SUBJECT: PECONIC RIVER SEDIMENT TRAP REMOVAL WORK/SAMPLING AND ANALYSIS PLAN

BNL Groundwater Protection Group
Final Responses to November 20, 2009 NYS DEC and DOH Comments on Peconic River Sediment Trap Removal Work/Sampling and Analysis Plan, dated October 8, 2009

**PECONIC RIVER SEDIMENT TRAP REMOVAL
WORK/SAMPLING AND ANALYSIS PLAN**

TITLE: PROPOSED SEDIMENT TRAP SAMPLE POINTS

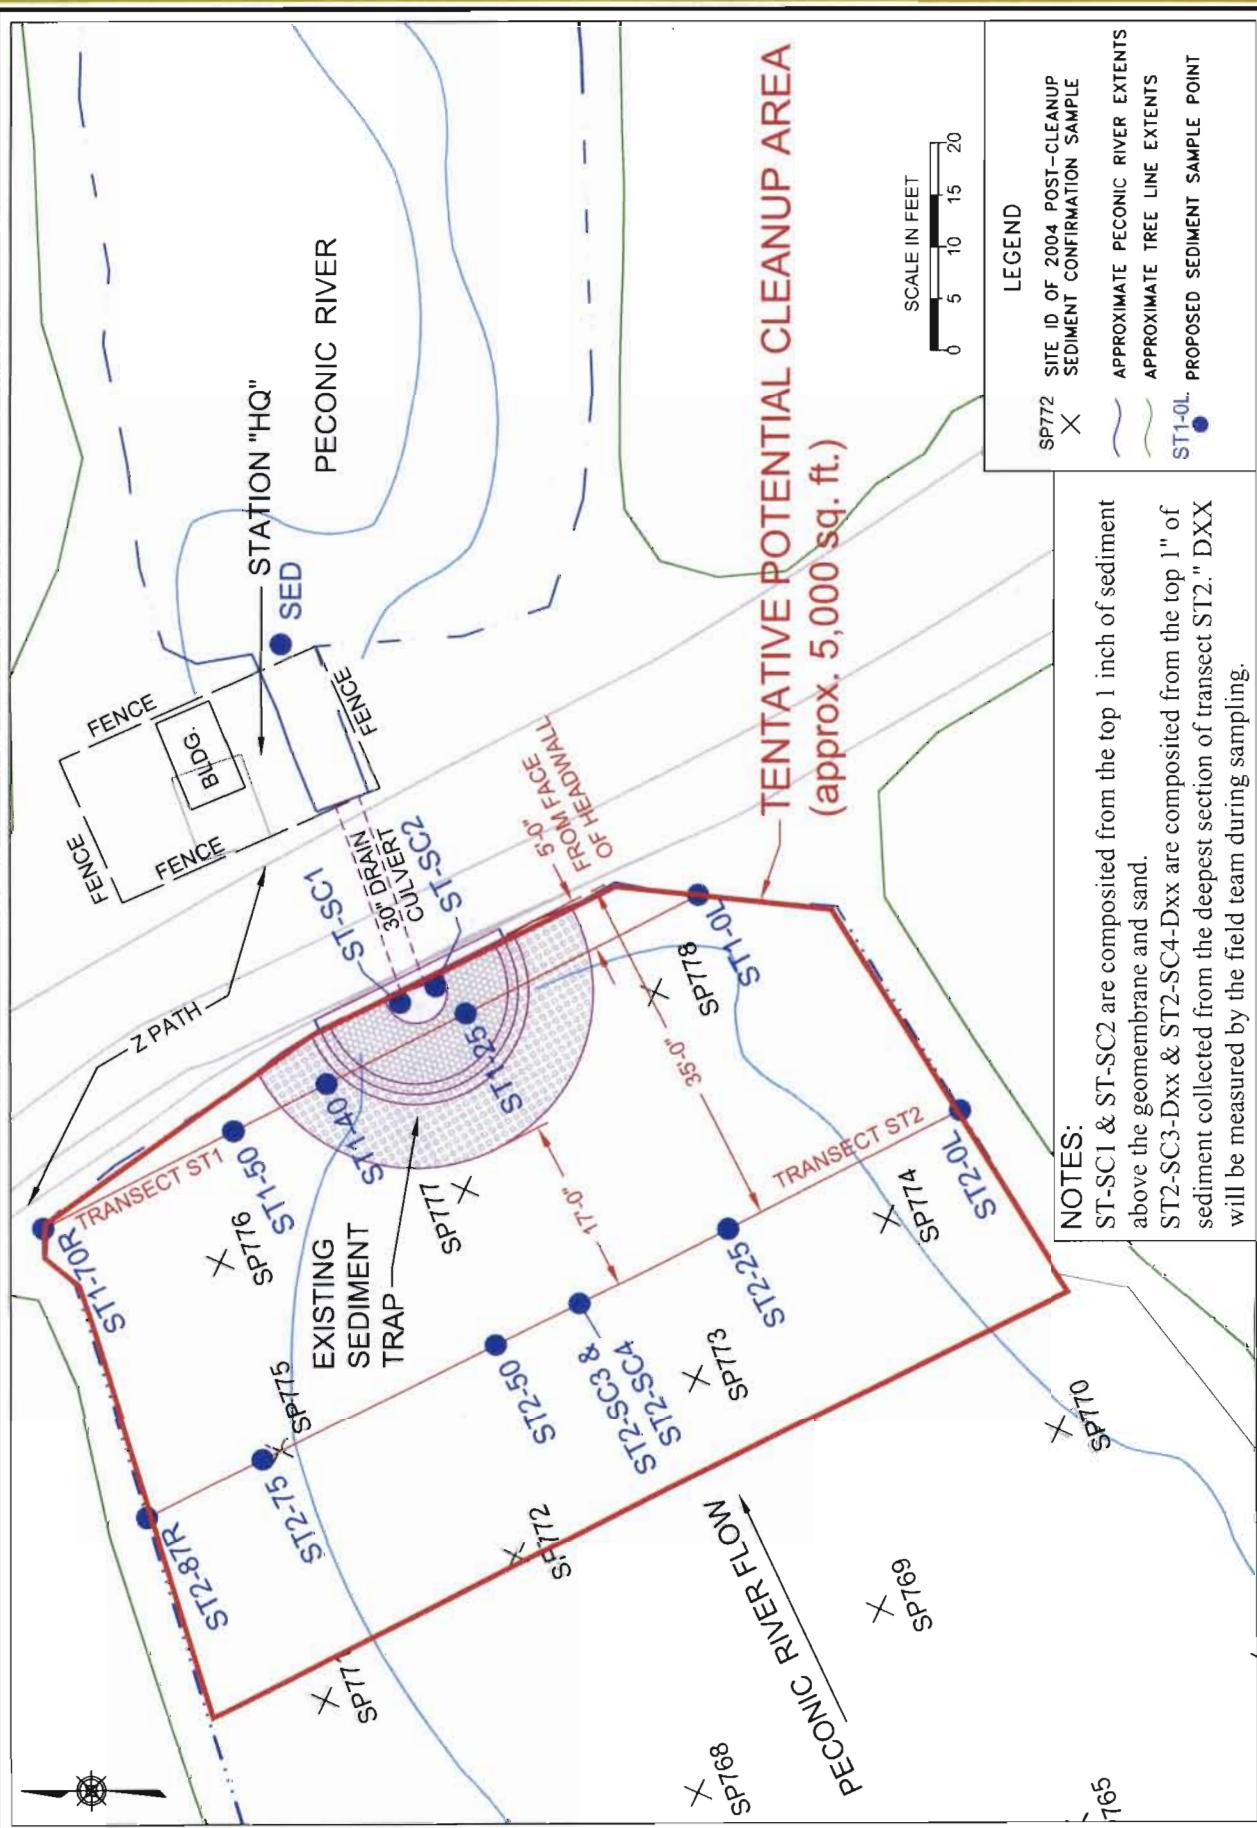
7	Page 10, Section 9.2	Does the collection of the two core samples within the removed sediment trap (STI-25 and STI-40) necessitate the puncturing of the geo-membrane? If so, are there any plans to patch up the geo-membrane?	If the geomembrane can not be peeled/rolled-back to expose a sample location without compromising the integrity of the geomembrane, it will be necessary to penetrate the geomembrane to collect the sample. In that case the geomembrane will be repaired.

Comment Number	Section/ Page	Comment	Response
8	Page 10, Section 9.2	The Department proposed that another sediment sample be collected at the other opening of the 30" drain culvert (adjacent to Station HQ) to test the effectiveness of the sediment trap.	An additional six inch sediment core sample will be included immediately downgradient of the location where the culvert effluent enters the river.
